**SNAKE RIVER PLAIN AQUIFER  
MODEL SCENARIO:**

***THE SOURCES OF DRAWDOWN AT A&B***  
***“A&B Scenario”***

May, 2005

## Appendix 1 HDR Comments

**Figure 2. Drawdown at A&B due to pumping within the A&B service area only.**

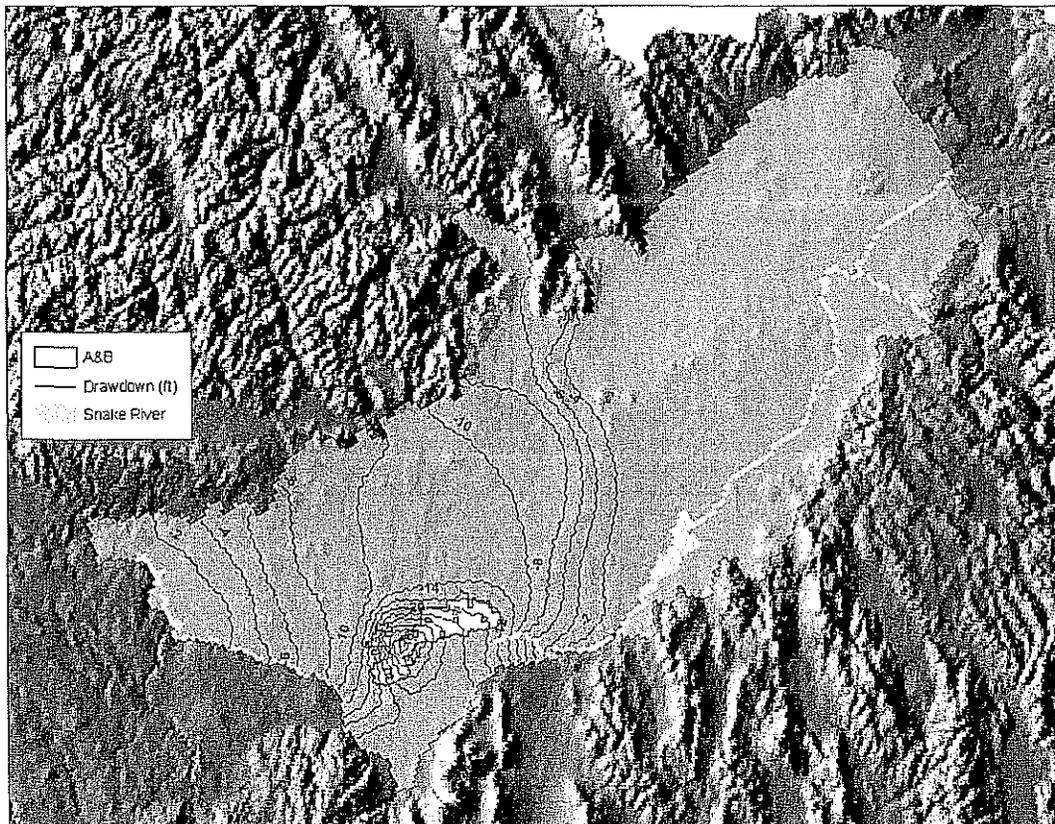
We understand that drains are not included in the super-position analysis. If this is the case, please remove the drain cells from Figures 2 to 4.

The predicted drawdown shown in Figures 2 to 4 exceeds the observed drawdown in the aquifer at areas near A&B Irrigation District and south of the District. Please explain these results.

Accept.

Accept. I will add an explanation to the summary section.

**Figure 3. Drawdown at A&B due to all other ground water irrigation.**

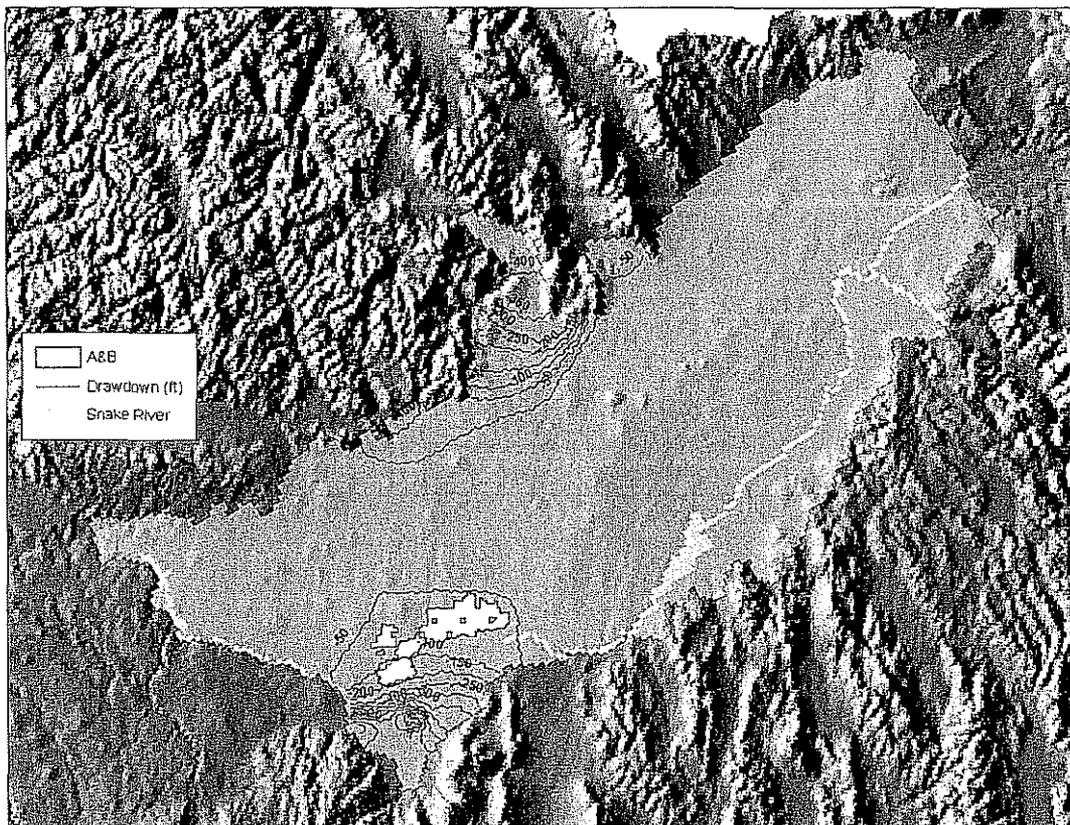
The scenario results in Figure 3 seem to show boundary effects in the Oakley Fan and Big Lost River area. Please explain.

Accept. We will add a paragraph to that effect in the "others" scenario.
